HISTORIC AND DESIGN REVIEW COMMISSION

March 01, 2017

HDRC CASE NO: 2017-080
ADDRESS: 507 KINGS COURT
LEGAL DESCRIPTION: NCB 3094 BLK 10 LOT 24
ZONING: R-4
CITY COUNCIL DIST.: 1
DISTRICT: Monte Vista Historic District
APPLICANT: Arthur Gonzalez
OWNER: Arthur Gonzalez
TYPE OF WORK: Construct rear accessory structure
REQUEST:

The applicant is requesting a Certificate of Appropriateness for approval to construct a two-story 20' by 20' rear accessory structure.

PLAN - R - 0000 - B
GONZALES RESIDENCE
 507 KING COURT

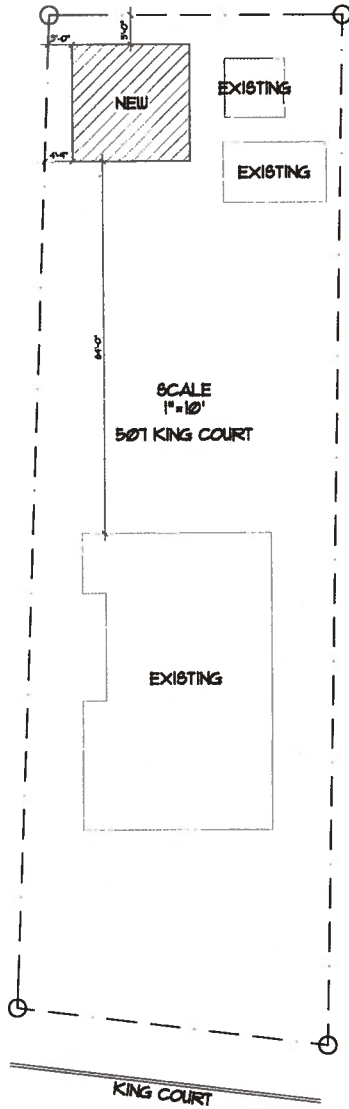
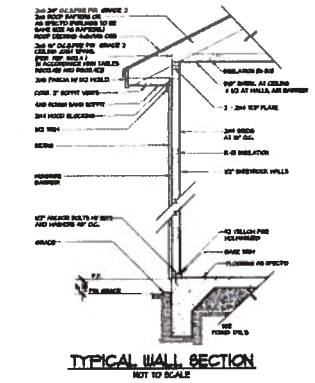
- d. **CHARACTER** – The main structure is a craftsman style house of modest size featuring asbestos siding, a front gabled roof with composition shingles, and a front chimney. The proposed rear accessory structure has a front gable roof, vertical plywood panel, a composition shingle roof, is two-stories, and 400 square feet. The building lacks architectural ornamentation and compatible design elements such as trim, eave, and siding details. According to the Guidelines for New Construction 5.A.iii., new outbuildings should relate to the period of construction of the principal building. The overall design and selected materials are not compatible with the character of the primary structure on the property and are not appropriate.

- e. **MASSING/FORM** – The proposed accessory structure is a two-story set to the rear of the main structure. It has an uninterrupted wall plane that is 13’ tall and a 20’ x 20’ footprint. According to the Guidelines for New Construction 5.A., new outbuildings should be no larger in plan than 40% of the principal historic structure’s foot print, and should be visibly subordinate to historic structures. Staff made a site visit February 24, 2017, and found that the proposed garage would be minimally seen from the public right-of-way as it is set to the rear of the main structure. However, the outbuilding is taller than other structures on the property, and uninterrupted mass of the wall planes contribute to the visual dominance of the structure.

- f. **WINDOWS/DOORS** – The proposed accessory structure has seven vinyl windows with false dividing lights. According to the Guidelines for New Construction 5.A.v., doors and windows should be similar in proportion and materials as those traditional found in the district. Staff finds the proposed windows are not consistent with the Guidelines. Staff finds wood one over one windows would be appropriate. Additional fenestrations on blank walls would also be more appropriate.

Staff recommends does not recommend approval based on findings a through f. Staff recommends that the overall design be modified to include architectural features, materials, and fenestrations that are compatible within the historic district.
